**Development of Columbarium at Sandy Ridge
Cemetery – Infrastructural Works at Man Kam To Road
and Lin Ma Hang Road**

Environmental Permit No. EP-534/2017/A

Layout Plan for the proposed footpath at Lin Ma Hang Road

Document No: CV/2017/02/R0023r3

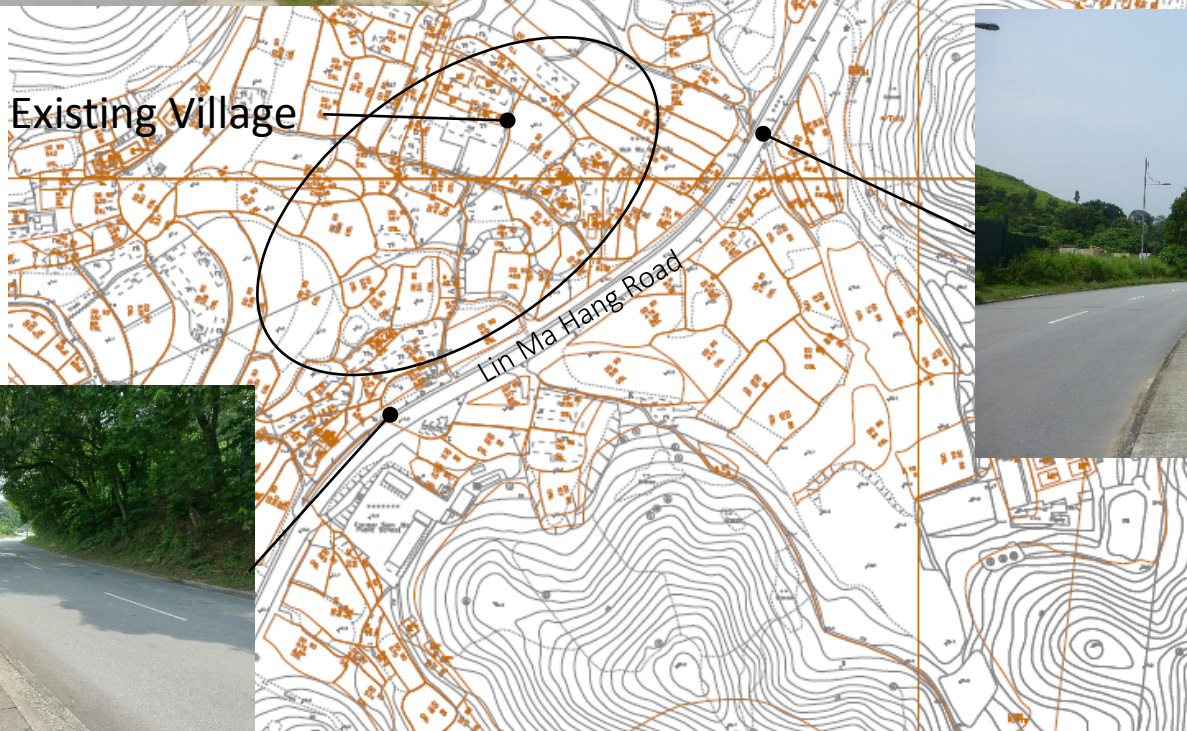
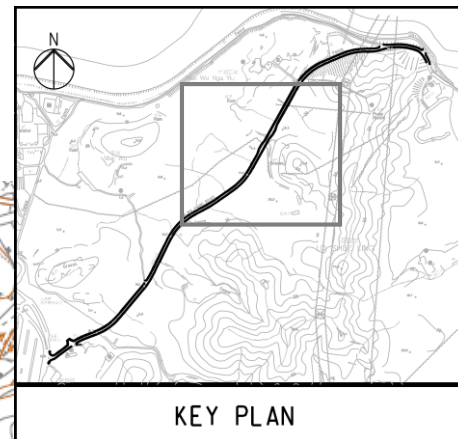
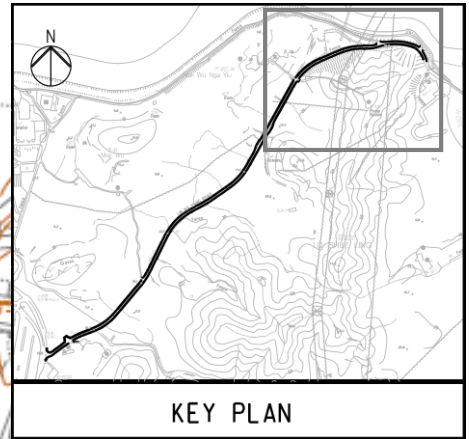
Comments received:	Responses:
<p>(1) From ACE Ref : Email Time: 11:05am Date : 8 December 2016</p> <p>I am very disappointed with the technical note which provided no “justification” for the need of new footpath except that “there are residents on both sides of the road” (which is already mentioned in the meetings). I would expect to see some figures on how many people are living on that side of the newly propose footpath sessions. I would actually expect sample counting be taken at those newly proposed sections and how many people walked along both sides of Lin Ma Hang Road during working days and public holidays. Why couldn’t the people cross the road and use the footpath on the other side? Also, how would the Project Proponent prevent illegal parking along the footpath in future?</p>	<p>The need for providing footpath is driven by the location of existing access points to nearby villages/ existing facilities/ existing settlement/ temporary structures/ proposed laybys rather than the number of pedestrians. The extent of the newly proposed footpath along Lin Ma Hang Road has been reviewed with due considerations of safety of road users, the continuity of footpath, road users’ experience (i.e. pedestrian do not need to frequently cross the road or drivers do not need to stop frequently to give way to pedestrian at crossings), as well as the environmental impact to the existing environment. In general, the existing footpath width are maintained and newly proposed footpath are only provided for pedestrian access to nearby villages/ existing facilities/ existing settlement/ temporary structures/ proposed laybys along Lin Ma Hang Road via the existing access points (see enclosed Sketch Nos. 231448/SK/213 to 230 for the location of existing structures).</p> <p>The extent of footpath provision on both sides of Lin Ma Hang Road has been minimized as far as possible and some newly proposed footpath on the westbound are substituted by crossing facilities so as to direct pedestrians to the other side of the road to enhance pedestrian safety and allow wheelchair passage. However, provision of crossing facilities is subject to a number of factors such as sightline, minimum clearance from lay-by and junction, location of run-in, etc and is not always practicable. In accordance with TPD Volume 2 Chapter 3.6 and Volume 9 Chapters 2.4 and 2.5, run-ins should be sited as far as possible away from pedestrian crossings whereas the minimum separation distance between lay-by and pedestrian crossing is 30m. In addition, provision of crossing facilities also requires local road widening in order to cater for the central refuge. Railings would be provided for the crossing facility, where necessary, for the safety of pedestrian as well as to prevent illegal parking.</p> <p>As shown in Appendix B, majority of the areas along two sides of Lin Ma Hang Road Road are already disturbed by existing human activities and thus provision of footpath has minimal environmental impact on the surroundings. Based on the aforementioned considerations, certain sections of footpath as shown in Sketch Nos. 231448/SK/216, 226, 228, and 229 have been reduced / deleted so as to avoid substantial slope works and thus minimise the impact on existing trees and woodland at the slope toes. The locations of trees which are avoided in the revised footpath layout and the site photos are shown in Sketch Nos. 231448/SK/213-230 and Appendix B respectively.</p> <p>For details of the justifications for each section of footpath, please refer to the updated Tables 2.1 and 2.2 in the attached main text. The existing constraints are also highlighted in Sketch Nos. 231448/SK/213 to 230.</p>

Sketch Title : LIN MA HANG ROAD - TRAFFIC SIGNS, DIRECTIONAL SIGNS AND ROAD MARKINGS (SHEET 1 OF 4)	
Scale : 1:500 @A1	Date : 09/01/2019

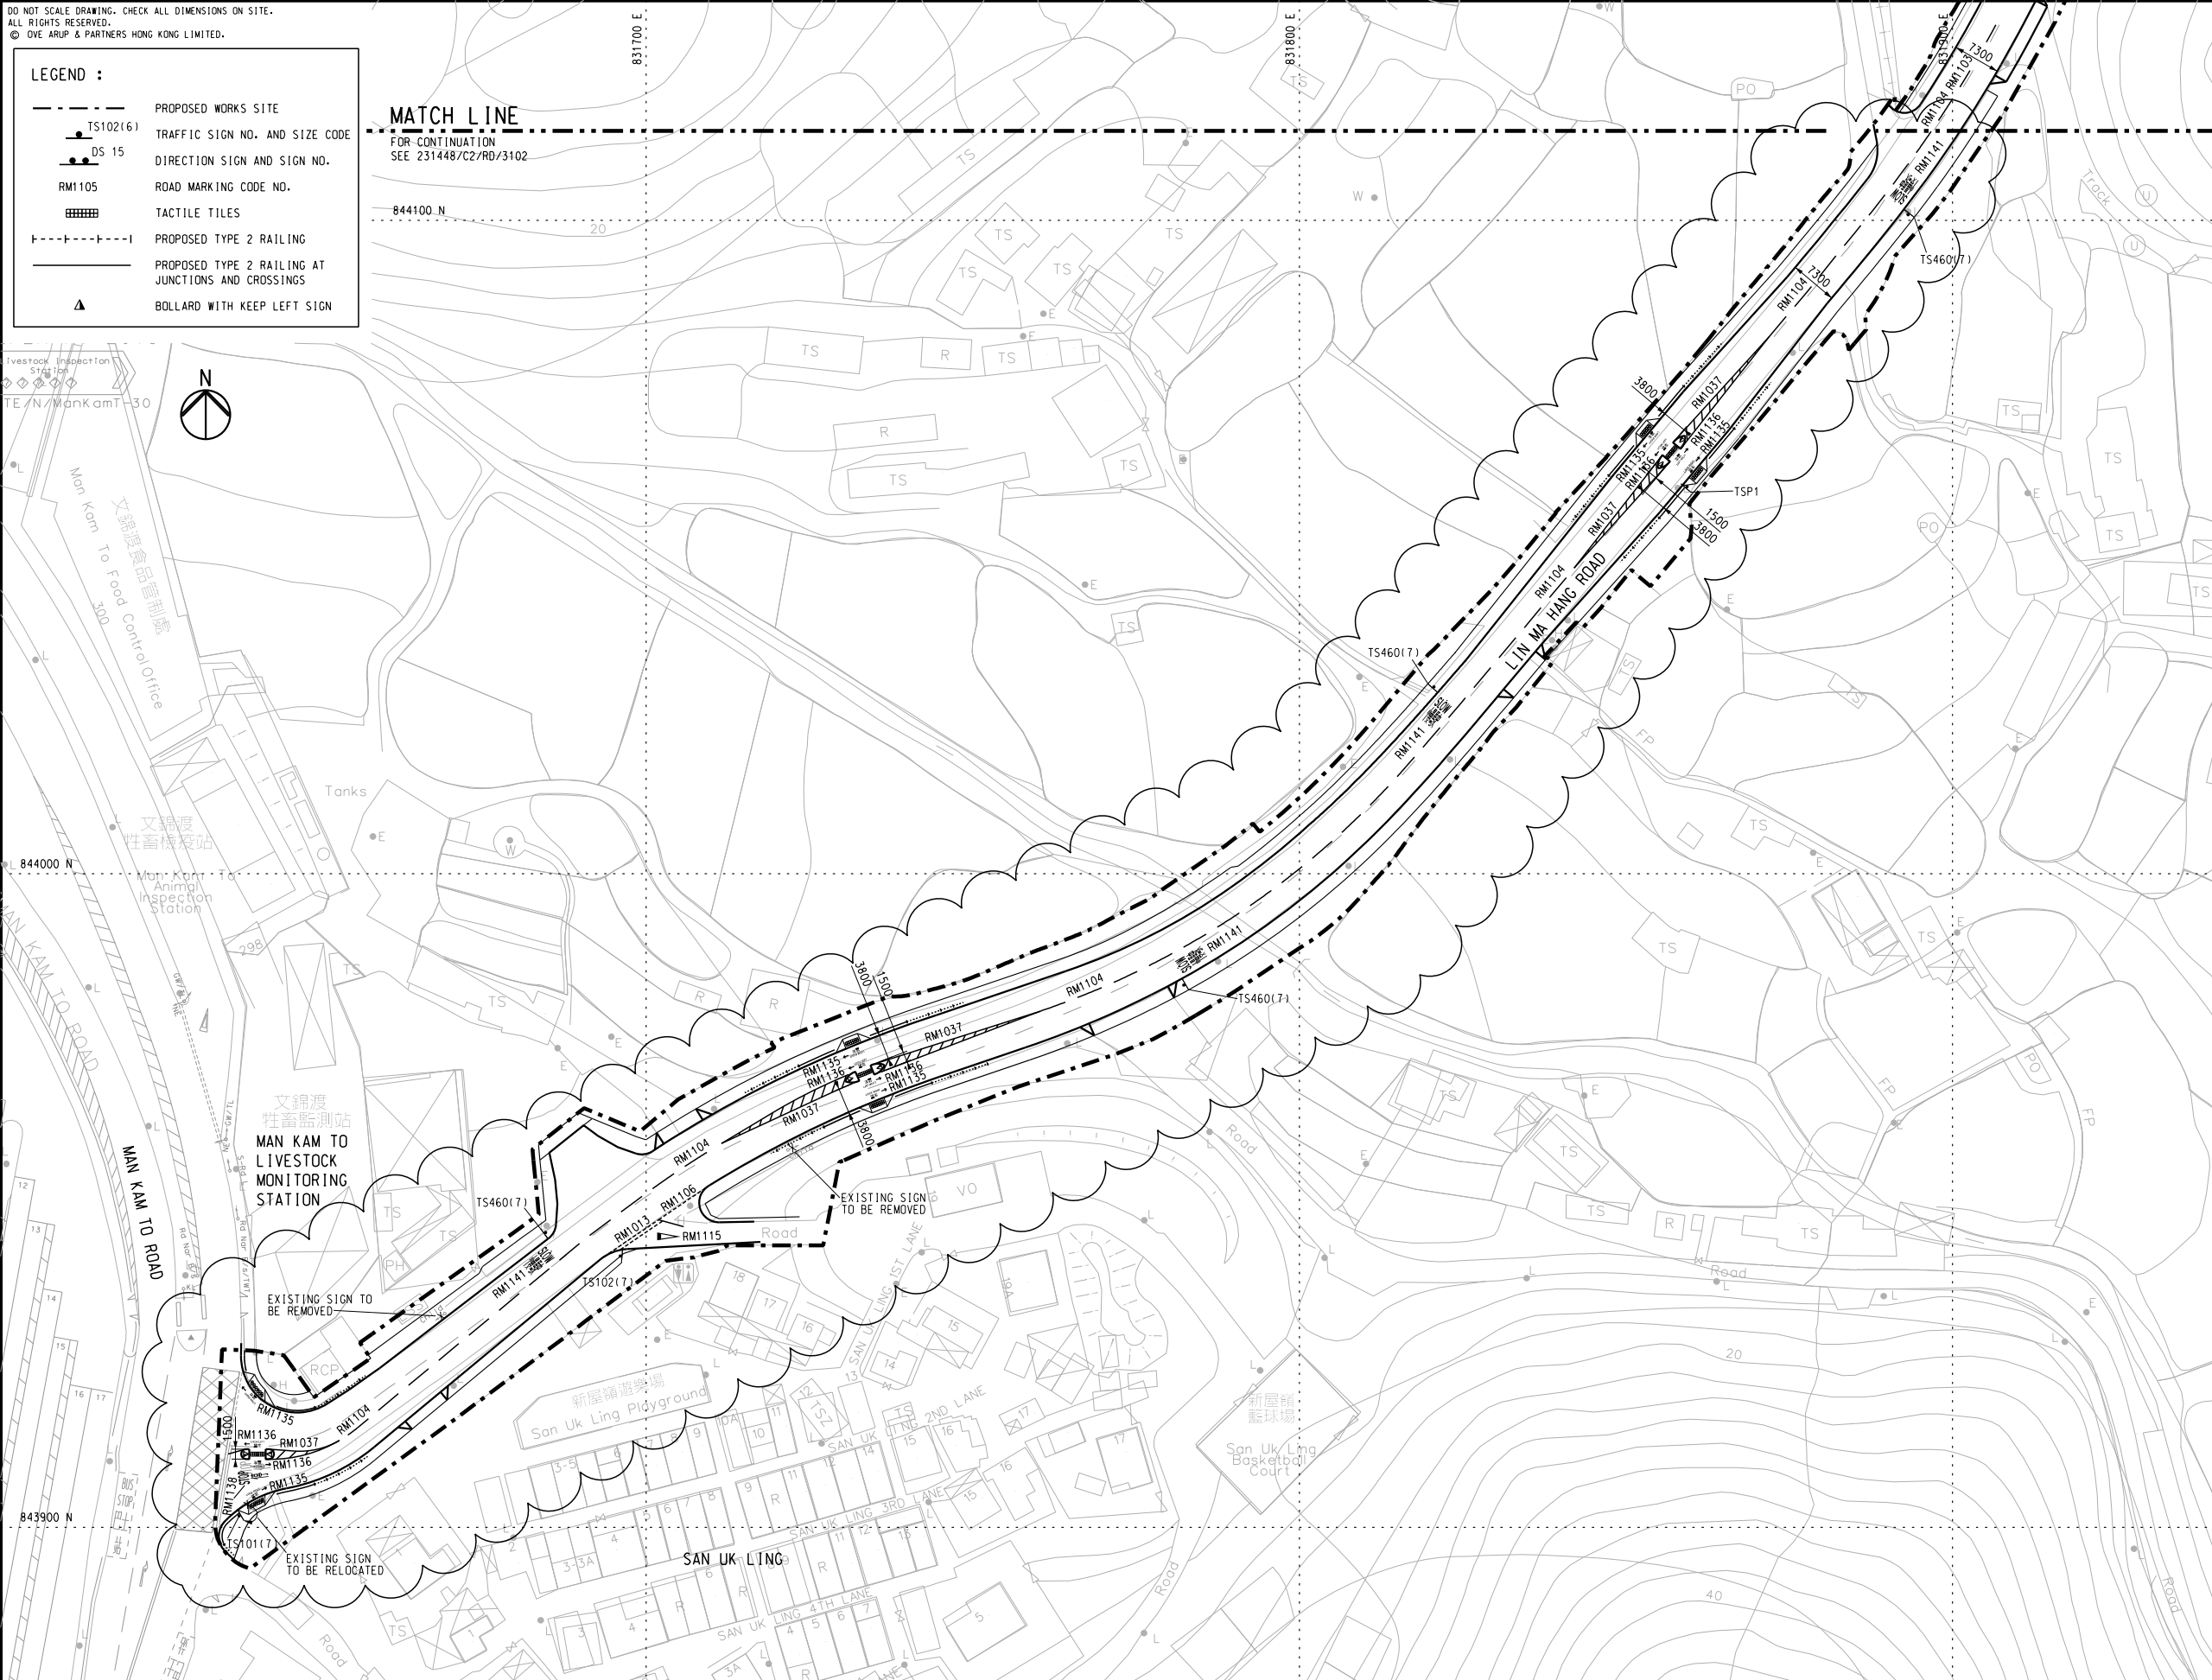
Comments received:	Responses:
<p>(1) From Transport Dept., NTR Ref : () in TDNR 171/200-280 Date : 22 October 2018</p> <p>We refer to your above referenced letter dated 11.10.2018 regarding the proposed 7 crossing points along Lin Ma Hang Road. Please see our comments below.</p> <p>TD's comment</p> <p><u>Drawing : 23144/C2/RD/3101B, Crossing Point 1</u></p> <p>The road width at the crossing point should be 3.8m (traffic lane) + 1.5m (refuge island) +4.5m (traffic lane) and the refuge island should be set back 3m from the junction to meet the requirement in TPDM. Please revise your design.</p> <p>Please provide swept path to show it is feasible to cater for 12.8m long FB.</p> <p><u>Drawing : 23144/C2/RD/3101B, Crossing Point 2, 3</u></p> <p>We have no further comment on the proposed road configuration at the crossing point with 3.8 wide traffic lanes on both sides of the 1.5m wide refuge island as marked up on your drawing.</p> <p><u>Drawing : 23144/C2/RD/3102A, Crossing Point 4</u></p> <p>We have no further comment on the proposed road configuration at the crossing point with 3.8 wide traffic lanes on both sides of the 1.5m wide refuge island as marked up on your drawing.</p>	<p>As 1.5m setback of refuge island is marginally sufficient for the left turning of 12.8m-long FB turning from Man Kam To Road S/B to Lin Ma Hang Road N/B (refer to Attachment A), further setback of the island will affect the turning of FB and induce safety concern if FB encroaches on the island. Deletion of refuge island has also been explored (Slide 1 refers), however pedestrians will have to cross the 15m-wide 2-way carriageway at the junction without provision of refuge island, which is not desirable from traffic and safety point of view.</p> <p>It has also been checked in Slide 2 of the attachment that the pedestrian crossing / refuge island has to be shifted into Lin Ma Hang Road by about 50m to cater for the turning of FB, causing the separation between the shifted crossing point 1 and crossing point 2 to be reduced to 65m only. In addition, the undesirable detouring arrangement will likely induce jaywalking to cross Lin Ma Hang Road near Man Kam To Road.</p> <p>In view of the foregoing and from traffic design perspective, it is recommended to maintain the refuge island at 1.5m setback from Man Kam To Road. If strict compliance with TPDM prevails, provision of crossing point 1 will be infeasible and thus removed from the current design.</p> <p>Noted with thanks.</p> <p>Noted with thanks.</p>
